# PERMIT

## SEWAGE DISPOSAL SYSTEM

#### HOWARD COUNTY HEALTH DEPARTMENT

SUBDIVISION Mat-Pet Estates LOT 3 ROAD 13047 Hall Shop Road

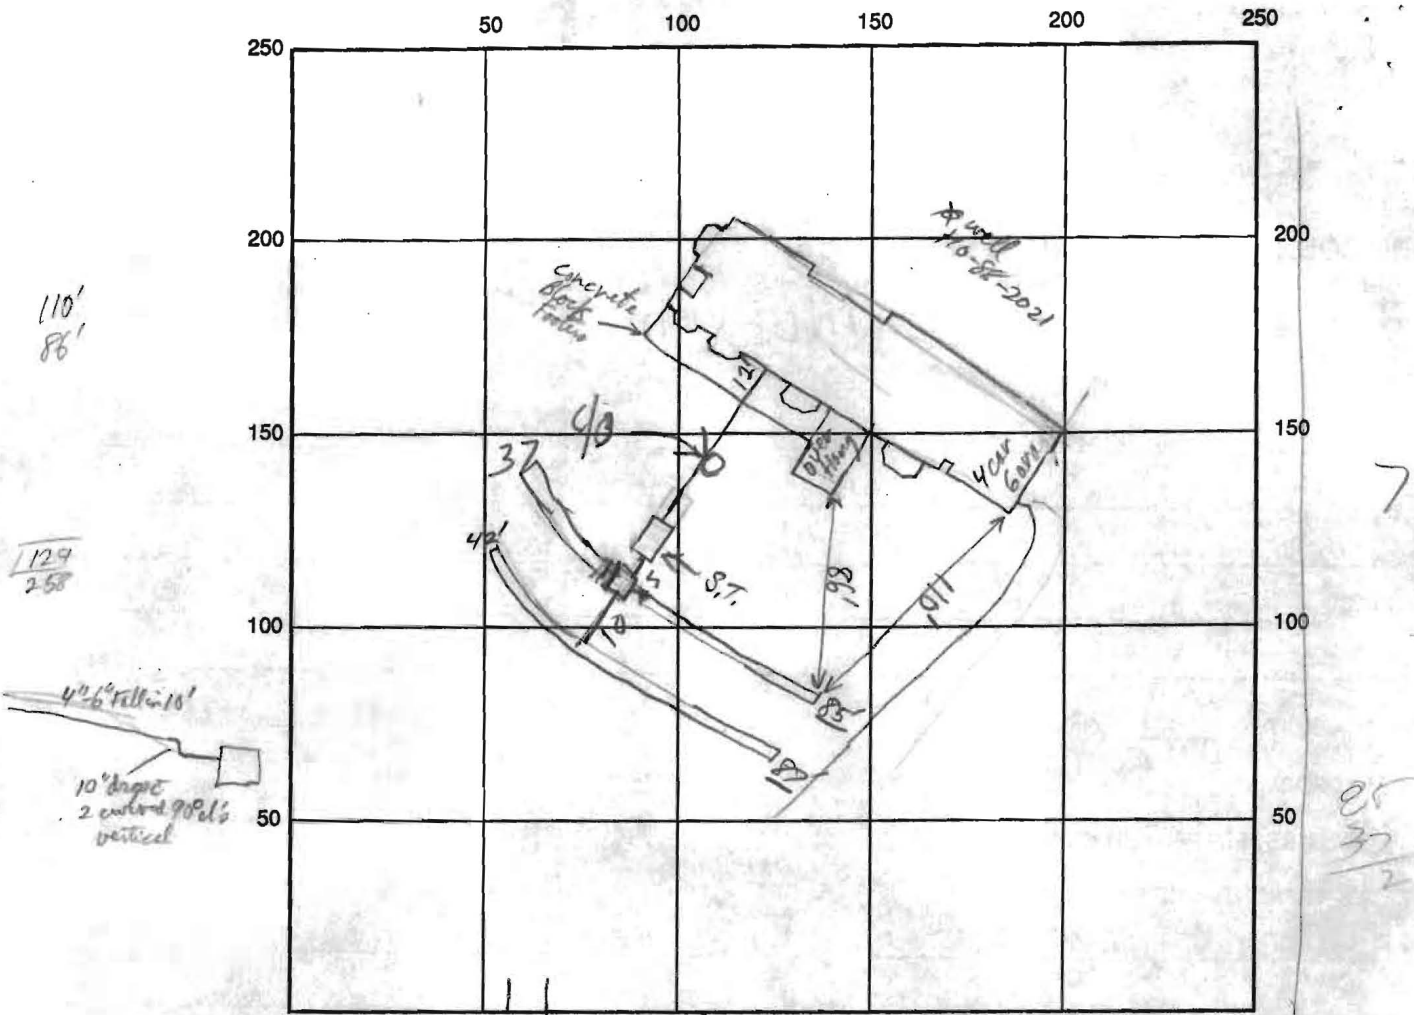
REMARKS: Some irregularities by installer - last 20'-30' of long trench is about 1ft shallower (in 6" layers) than main section. Trenches are continuous than 129ft length. Most of trench is deeper than specified but soil are loamy + old data suggest trench depth of 8 1/2 is still acceptable. Middle length of gravity pipe between House + S.T. is going to be pitched steeper than 1/4" / ft - Installer says he'll pitch last 10ft @ 1/4" before S.T.

6/25/92 ADD STONE TO HALF OF TRENCH CLOSEST TO HOUSE

9/18/92  
 REVISED PLANS OK  
 AFTER DISCUSSION OF ISSUES  
 WITH ENGINEER &  
 MAKING RED LINE CORRECTIONS  
 Biltodge  
 BP 45387

COVER REST OF SYSTEM RH 6/28/92 STONE ADDED
